In response to the Office Action mailed April 25, 2003, Applicants respectfully request that the Examiner reconsider his rejection of the specification, drawings and remaining claims.

Reply to Office Action of April 25, 2003

PATENT
U.S. Ser. No. 09/803,350

FIG. 2

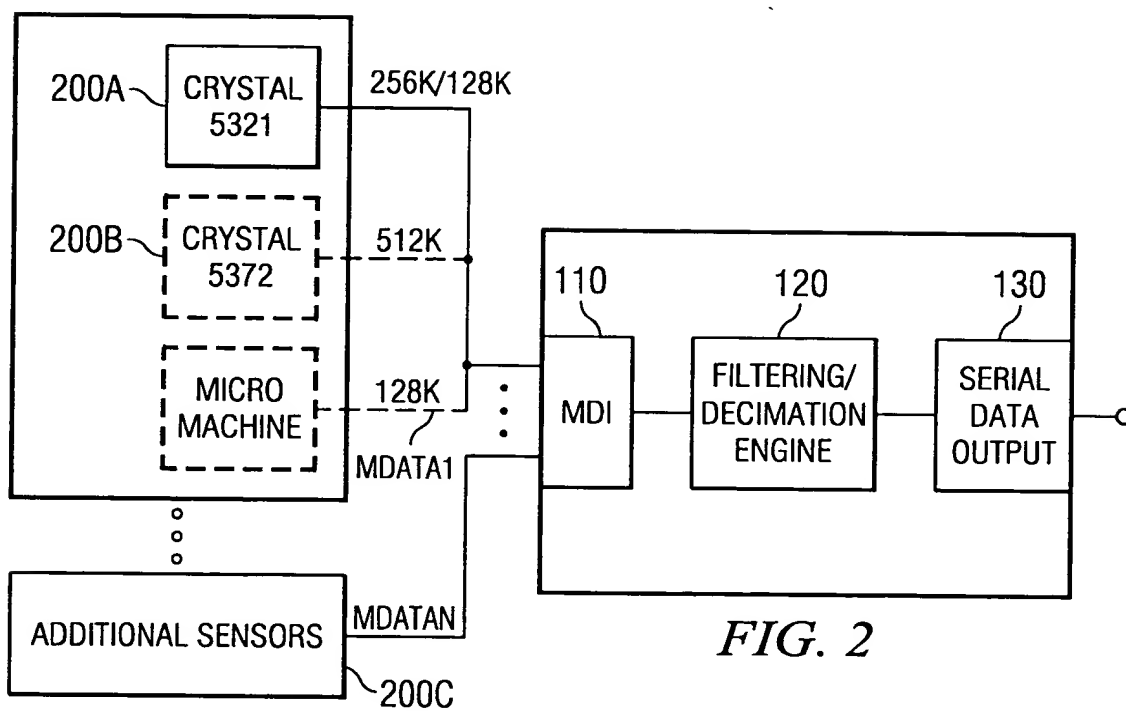
The drawings stand objected to under 37 C.F.R. 1.83(a) on the grounds that FIGURES 1-26 generally lack formality and particularly that FIGURES 2-4 and 31 contain unlabeled blocks that should be labeled according to their functions. All drawings currently being amended are shown with deletions struckthrough and additions indicated in red on the sheets attached for the convenience of the Examiner. Attached are replacement sheets that include the proposed changes.

ANNOTATED SHEET SHOWING CHANGES:
